**CITY OF WEST DES MOINES  
STAFF REPORT COMMUNICATION**

**ITEM:** Mill Ridge Plat 6, NW corner of Stagecoach Drive & S. 88<sup>th</sup> Street – Approve a Preliminary Plat to create sixty (60) footprint lots, two (2) outlots, and one (1) street lot for Multi-Family Residential development and Approve a Site Plan to allow construction of 60 attached townhomes with associated site improvements – Josh Trygstad, Civil Design Advantage – PPSP-005548-2022

**Resolution: Approval of Preliminary Plat and Site Plan**

**MILL RIDGE PLAT 6**  
**DIMENSION PLAN**

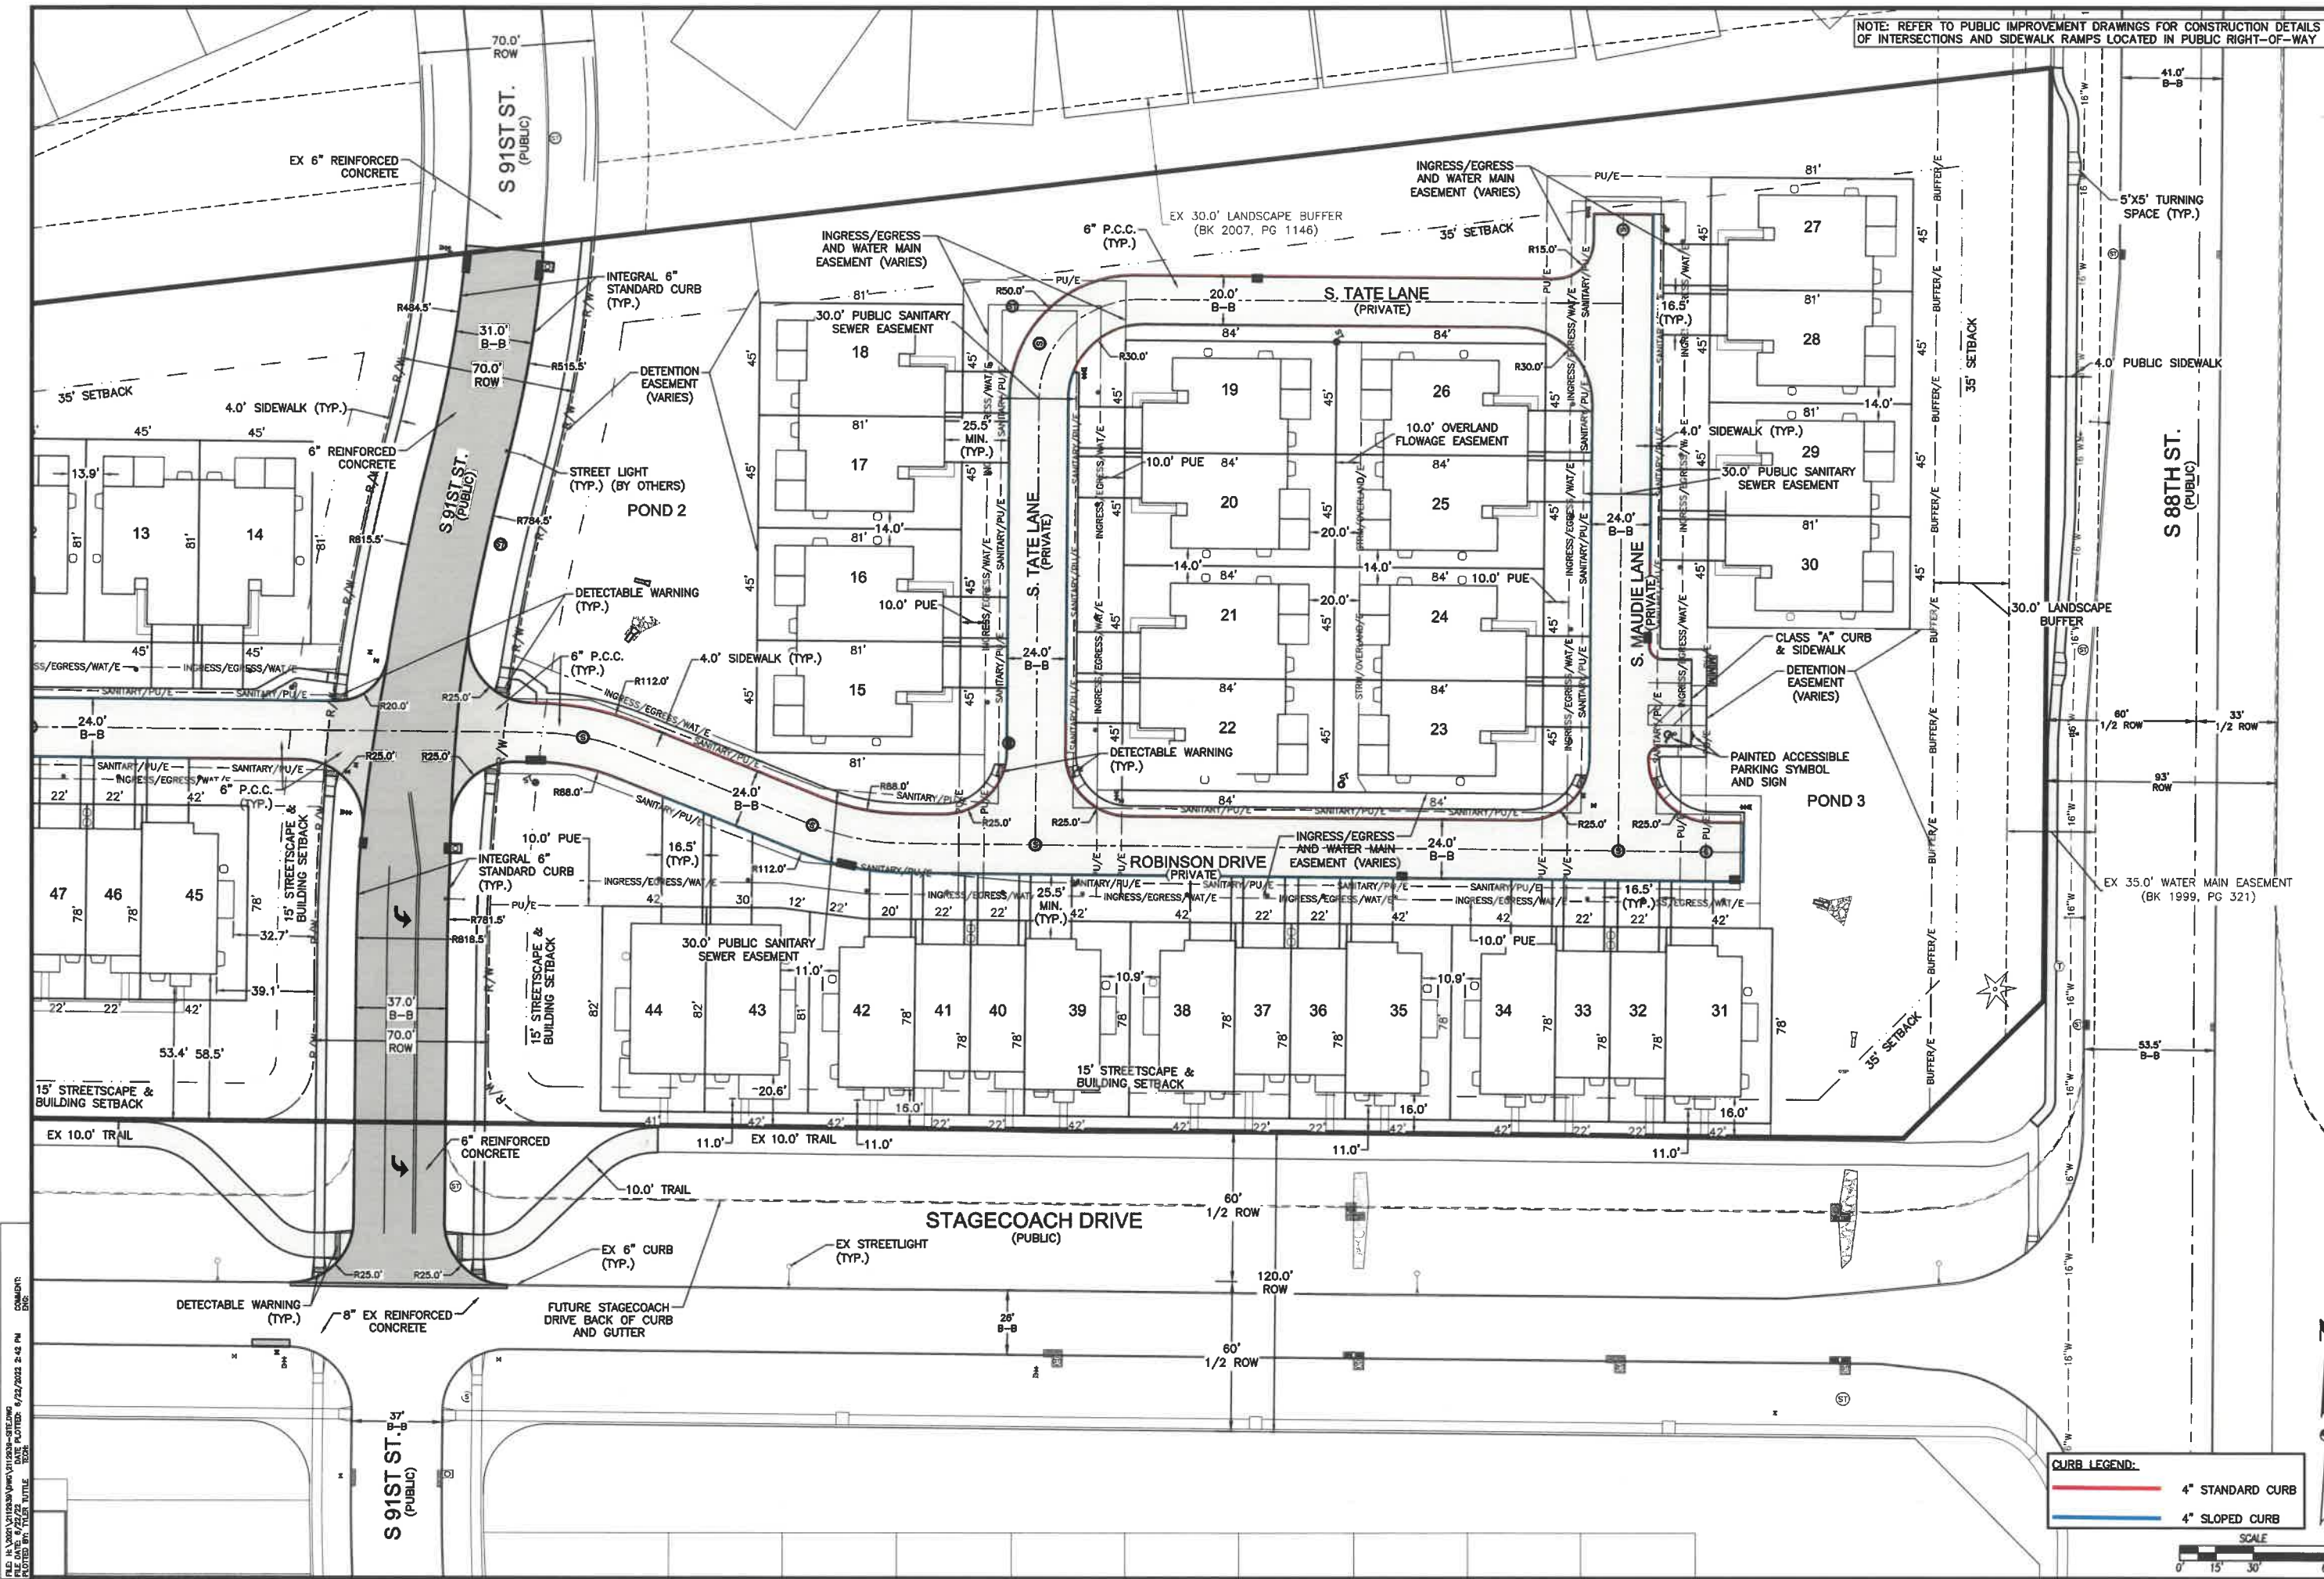
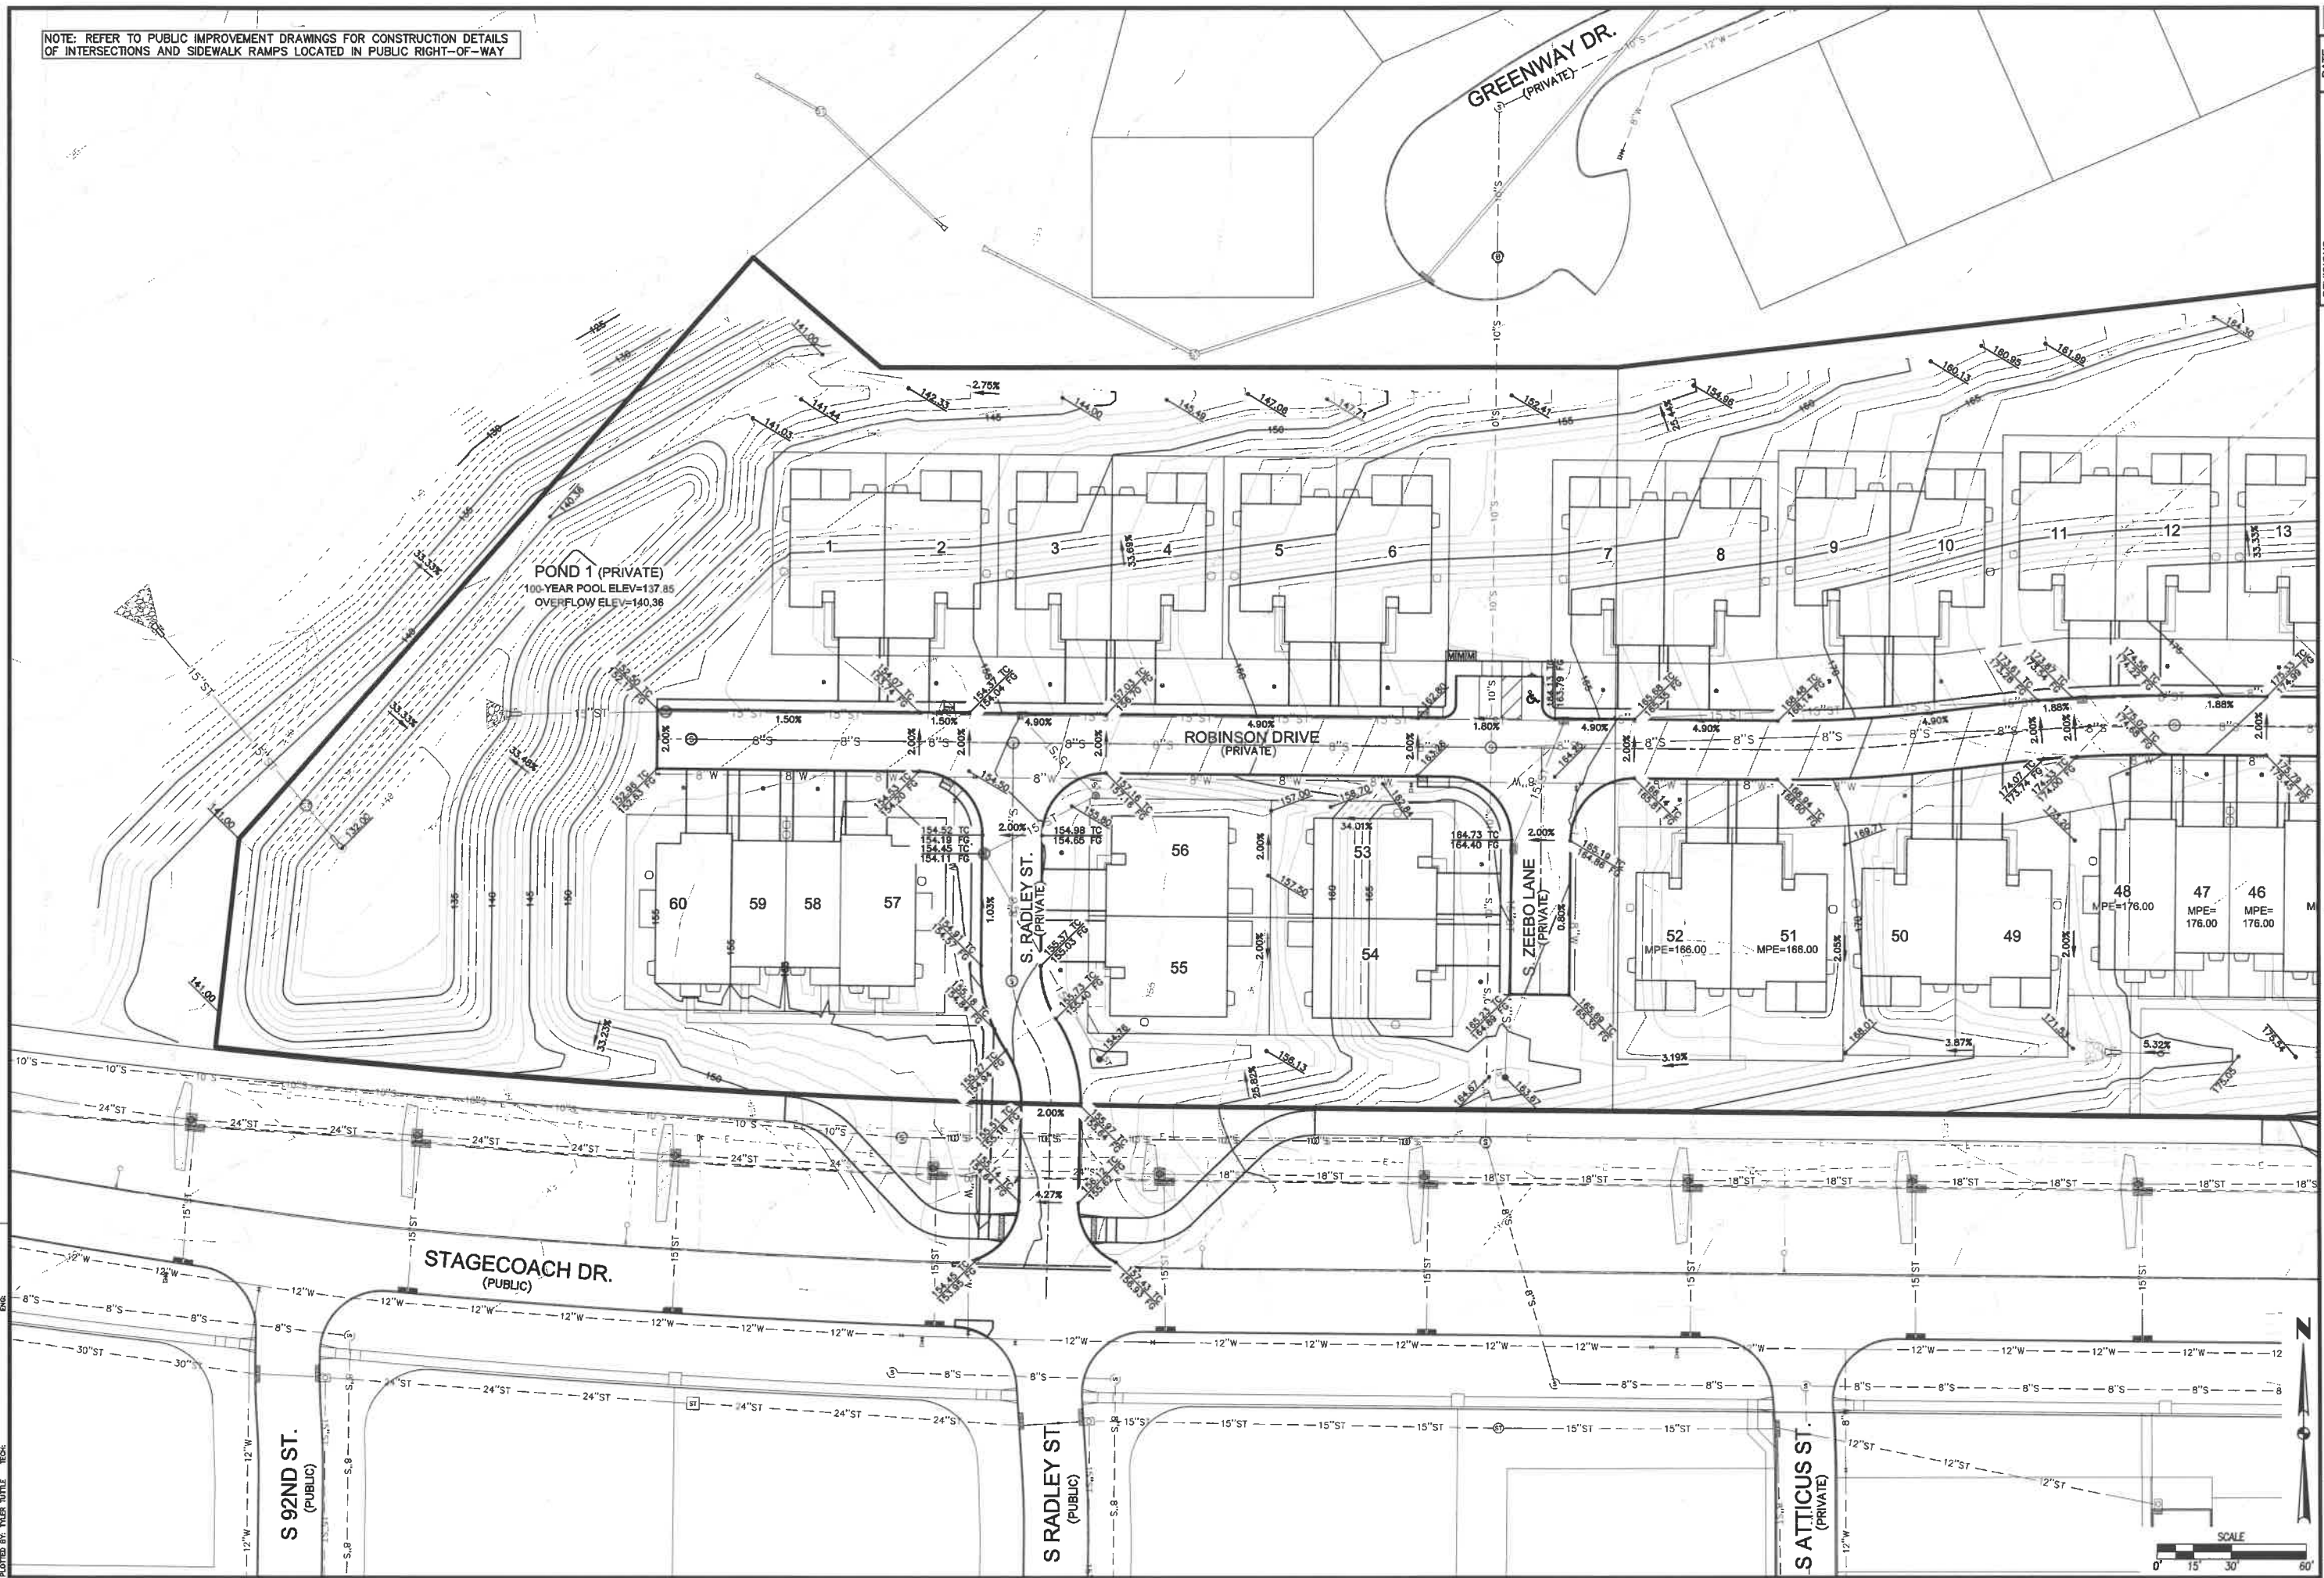
4. *Curbs along the Private Internal Roads:* As noted previously, the development is planned with interior private roads. The applicant is indicating pedestrian sidewalks within the development immediately adjacent to the roadway edge. City Code requires: "*All off-street parking lots and associated drive aisles, access roadways and frontage roads, shall be constructed with permanent, integrally attached, continuous Portland cement concrete curbing of at least four inches (4") high and six inches (6") wide or of alternate height and width acceptable to the City.*" Additionally, City Code states for Medium and High-Density developments, "... *All sidewalks, walkways and paths, shall be located and designed to provide adequate physical separation from vehicles along all public and private streets and drives within any parking area.*" The applicant was proposing the use of 4" high sloped curbs (aka rolled curbs) at the road edge at each individual dwelling driveway. The applicant had hoped to use the same 4" sloped curb along the entire edge of the private roadways within the development. While the 4" sloped curb meets the first requirement stated previously, staff does not believe a curb that is intended to allow vehicles to easily pass over it meets the intent of the second code provision of providing "adequate physical separation". Staff has no issues with the rolled curb at the individual unit driveways. As a compromise and for reasons of constructability, staff can support the use of the rolled curb in the gap between driveways. However, staff believes the balance of the roadway edge, especially that which has the sidewalk immediately adjacent, should be constructed with a minimum 4" standard (vertical) curb. Staff cannot agree that a curb specifically designed to allow vehicles to roll over it is providing an adequate safety barrier. Sheets C3.1 and C3.2 of the site plan are color coded to reflect where the rolled curb and standard vertical curb will be located.
